# Access Compliance Report

## Public Rights-of-Way

Intersection ID: 30238	Main Street: BLUE_TOPAZ_CT	Cross Street: SILVER_ORE_LN	Location: SW
ADA ID: 243E38621858	Ramp Type: PerpDiag	Initial Pass/Fail: Fail	Overall Compliance: No
Severity Score: 33.75			
Codes/Mitigation Info/Possible Solution		Field Measurements/Component Compliance

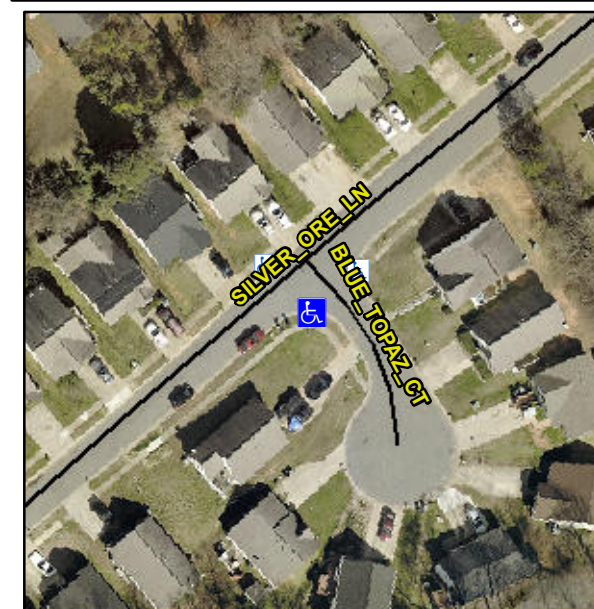
**Not Found, R304.5.1, R304.5.3**

Compliance	Description	Data	Compliance	Description	Data
N/A	Ramp Length (in)	46.0	Yes	Ramp Slope (%)	6.3
No	Ramp Width (in)	44.0	No	Ramp XSlope (%)	9.6
N/A	Flare Type LT	N/A	N/A	Flare Type RT	N/A
N/A	Flare Slope LT (%)	N/A	N/A	Flare Slope RT (%)	N/A
N/A	Flare Traversable LT?	N/A	N/A	Flare Traversable RT?	N/A
N/A	Landing Length (in)	N/A	N/A	DWS Provided?	N/A
N/A	Landing Width (in)	N/A	N/A	DWS Contrast?	N/A
N/A	Landing Slope (%)	N/A	N/A	DWS Length (in)	N/A
N/A	Landing X Slope (%)	N/A	N/A	DWS Full Width?	N/A
N/A	Landing Curb? (Y/N)	N/A	N/A	DWS Offset (in)	N/A
N/A	Shared Landing?	N/A			
N/A	Gutter Ponding?	N/A	N/A	Gutter Slope (%)	N/A
N/A	Gutter Lip Ht (in)	N/A	N/A	Gutter X Slope (%)	N/A
N/A	Painted X Walk1?	No	N/A	Painted X Walk2?	No
	X Walk 1 Direction	To NE		X Walk 2 Direction	To NW
N/A	X Walk 1 Width (in)	N/A	N/A	X Walk 2 Width (in)	N/A
	X Walk 1 Slope (%)	6.0		X Walk 2 Slope (%)	4.5
	X Walk 1 X Slope (%)	4.9		X Walk 2 X Slope (%)	8.6

**Remove & Replace Curb Ramp With Two New Directional Ramps or Equivalent.**
